Consumers
Power
Company

Re: Docket 50-155
DPR-6 ZEK

Request for Change to the Technical Specifications

License No DPR-6

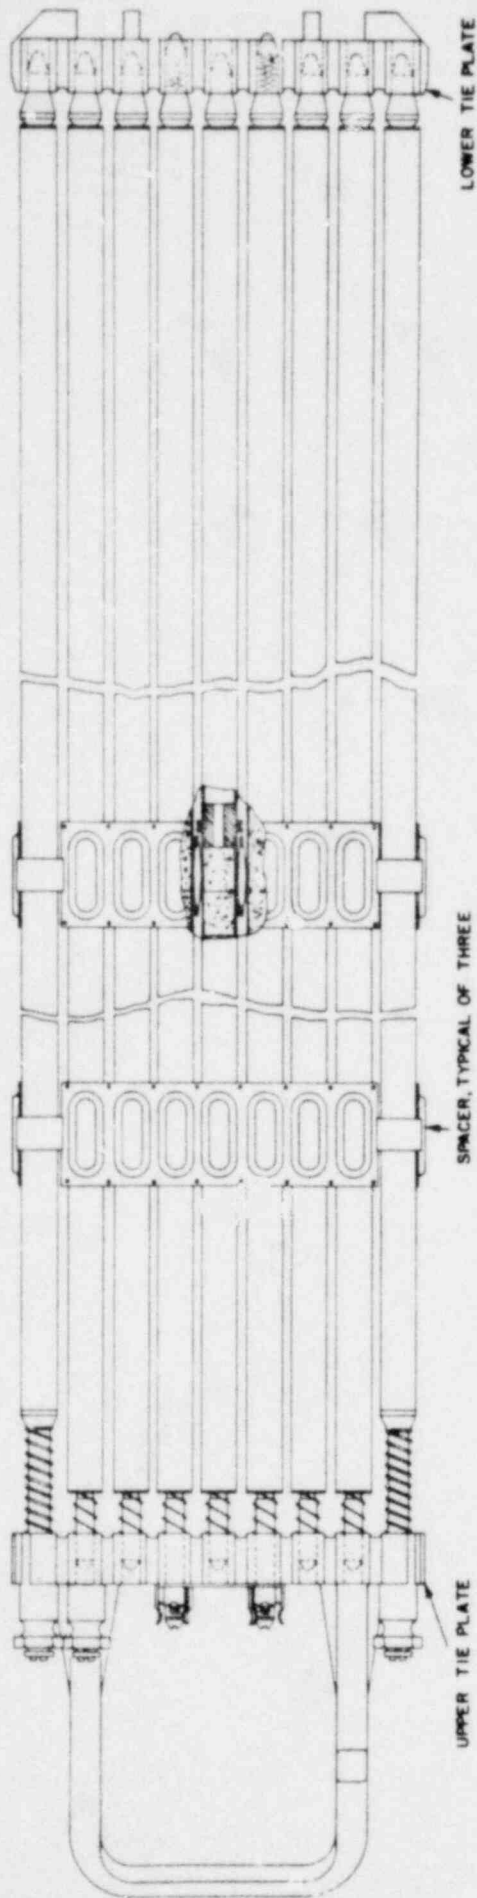
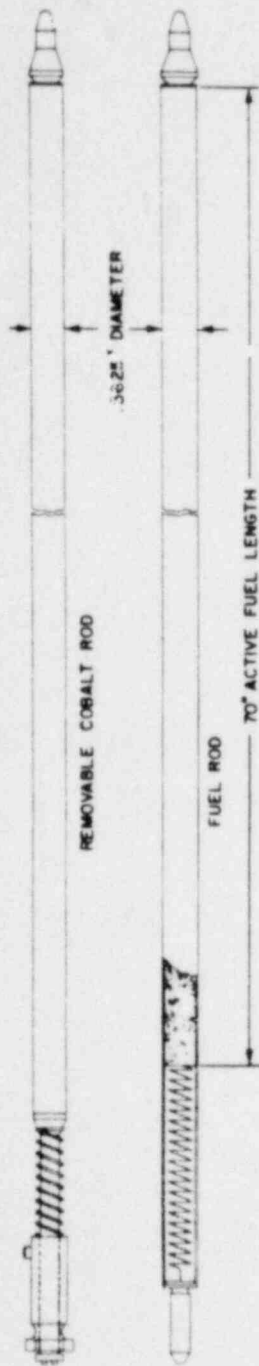
A. In Section 5.1.5, change "(c)" to read as follows:

(c) Fuel Bundles

"The general dimensions and configuration of the seven types of fuel bundles shall be shown in Figures 5.2, 5.3, 5.4, 5.5, 5.6, 5.7, and 8.1 of these specifications. Principal design features shall be essentially as follows:"

FIGURE 5.7 BIG ROCK POINT E AND E-G FUEL

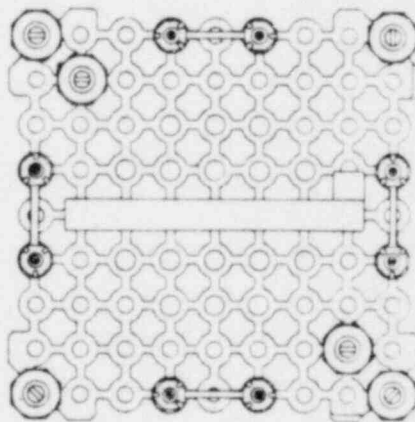
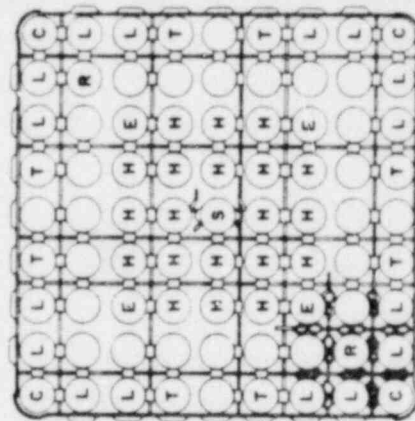
B. In Section 5.1.5, replace Figure 5.7 with the attached revised Figure 5.7.

The Reload "E-G" fuel is essentially identical physically to the Reload "E" fuel. The only differences being, an increase in the enrichment to enable the fuel to achieve approximately 20,000 Mwd/T compared to approximately 15,000 Mwd/T for the "E" reload; and the addition of gadolinium oxide burnable poison to four fuel rods to provide the required supplemental reactivity control.
